SPEAKERPHONE SYSTEMS— 3 TYPE CONTROL UNITS AND TRANSMITTER UNITS CONNECTIONS

1.02 This section is being reissued to:

Fig. 1A - Modification of P-12E658 Printed Wiring Board

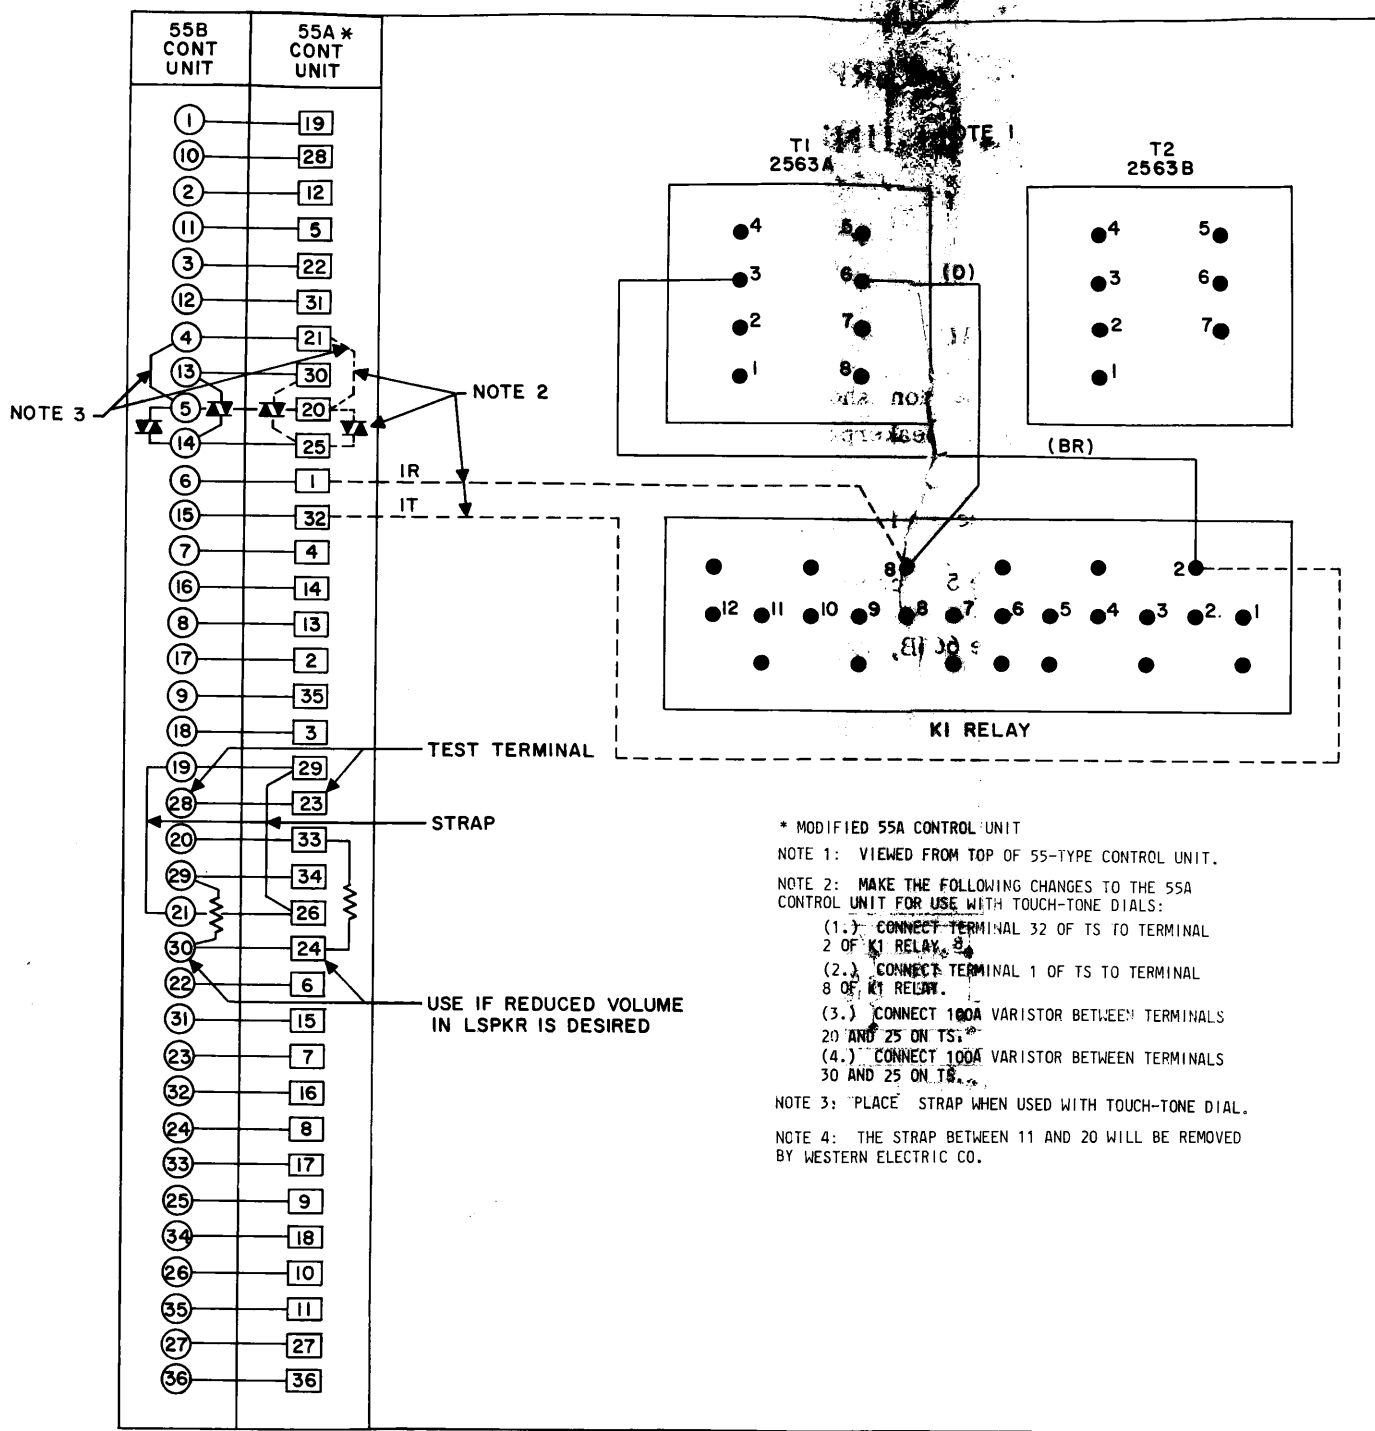
NOTE: 55A CONTROL UNITS MANUFACTURED BETWEEN APRIL AND OCTOBER OF 1962 ARE PRONE TO NOISE PROBLEMS. THESE CONTROL UNITS WERE WIRED ACCORDING TO FIG. 1A. THESE UNITS SHOULD BE REPLACED WITH CONTROL UNITS WIRED PER FIG. 1. DO NOT MODIFY CONTROL UNIT IN THE FIELD.
